Work Order ID 134676 -

Item Name: Lug

DRAWING NO. D3394	TITLE LUG	REV. B	DART AEROSPACE LTD ENGINEERING ORDER		D.E.O. NO. D3394-B-1	SHEET NO. SHEET 1 OF 1	SCALE NTS
DRAWN AJS	CHECKED	MFG. APPR.	APPROVED		DE APPR.		
DATE 09.11.04	DATE 09.11.04	DATE 09.11.04	DATE 09/11/04		DATE 09/11/04

DRAWING NO. D3394	TITLE LUG	REV. B	DART AEROSPACE USA, INC ENGINEERING ORDER		D.E.O. NO. D3394-B-2	SHEET NO. SHEET 1 OF 1	SCALE NTS
DRAWN <i>GP</i>	CHECKED <i>SC</i>	MFG. APPR. <i>M</i>	APPROVED <i>MP</i>		DE APPR. <i>MP</i>		
DATE 11.05.02	DATE 11.05.09	DATE 11.05.09	DATE 11.05.09		DATE 11.05.09

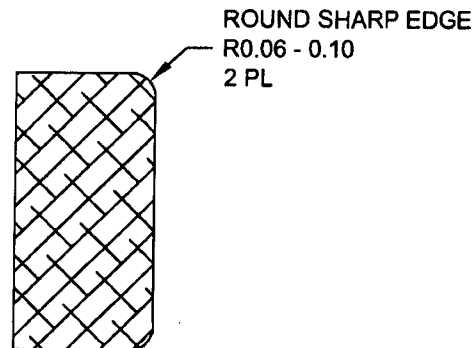
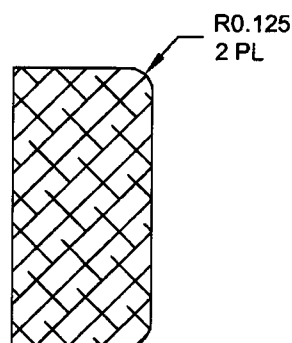
SHEET 4 ZONE A,1 MODIFY SECTION A-A AS SHOWN:

REASON: DRAFTING ERROR

IS:

WAS:

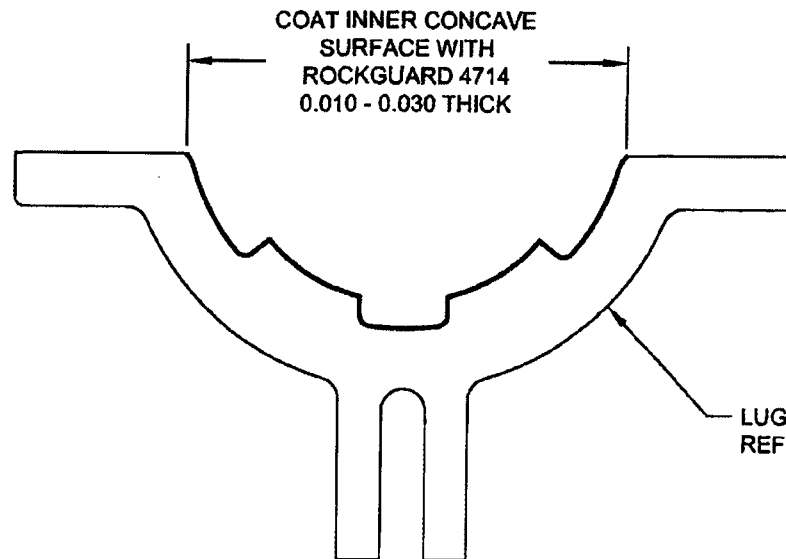
ADD D3394-xRG OPTION

D3394-xRG MOUNTING LUGS ARE INDENTICAL TO D3394-x MOUNTING LUGS, HOWEVER AFTER FINISH, COAT INNER CONCAVE SURFACE WITH "PLUS ONE ROCKGUARD 4714" AS SHOWN BELOW.

D3394-1RG LUG (SHOWN)
D3394-3RG/-5RG LUGS (SIMILAR)
D3394-041RG/-043RG/-045RG LUG ASSEMBLIES (SIMILAR)
